CITY OF AUSTIN
APPLICATION TO BOARD OF ADJUSTMENT
INTERPRETATIONS
PART I: APPLICANT'S STATEMENT
(Please type)

STREET ADDRESS: 4605 Avenue B

Re: An Administrative Appeal Request
Case No. C15-2011-0014.
Property Address: 4605 Avenue B

Exhibit A

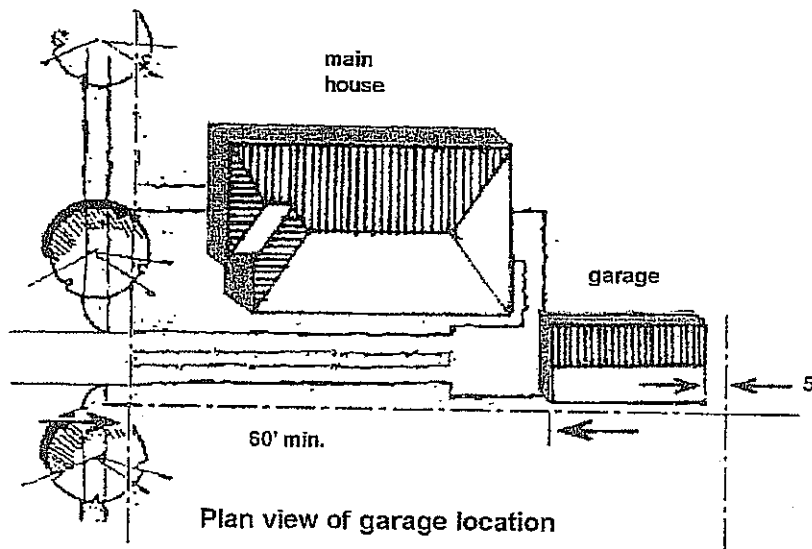
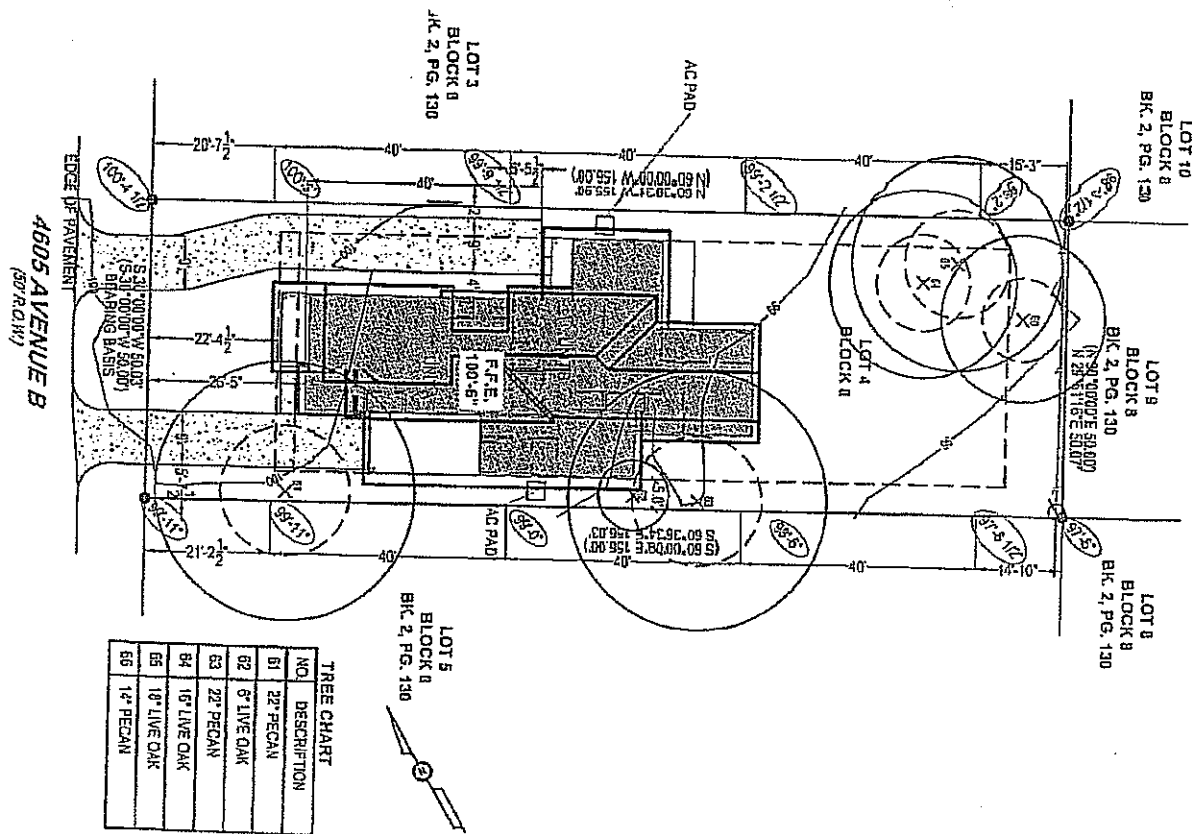
The proposed design shows the parking facility (a carport) on the ground floor and behind the front façade of Unit A, which is the front part of the building. Staff feels this section of the ordinance has been met in the proposed design, and the ordinance does not prescribe the distance or length the parking facility needs to be located behind the pedestrian-oriented use. In exhibit A, which is taken from the Hyde Park Design

guidelines that accompanied their NCCD, shows a picture in the bottom right hand corner of an attached carport and driveway sharing an area equal distance from the side property line with a portion of the residential structure.
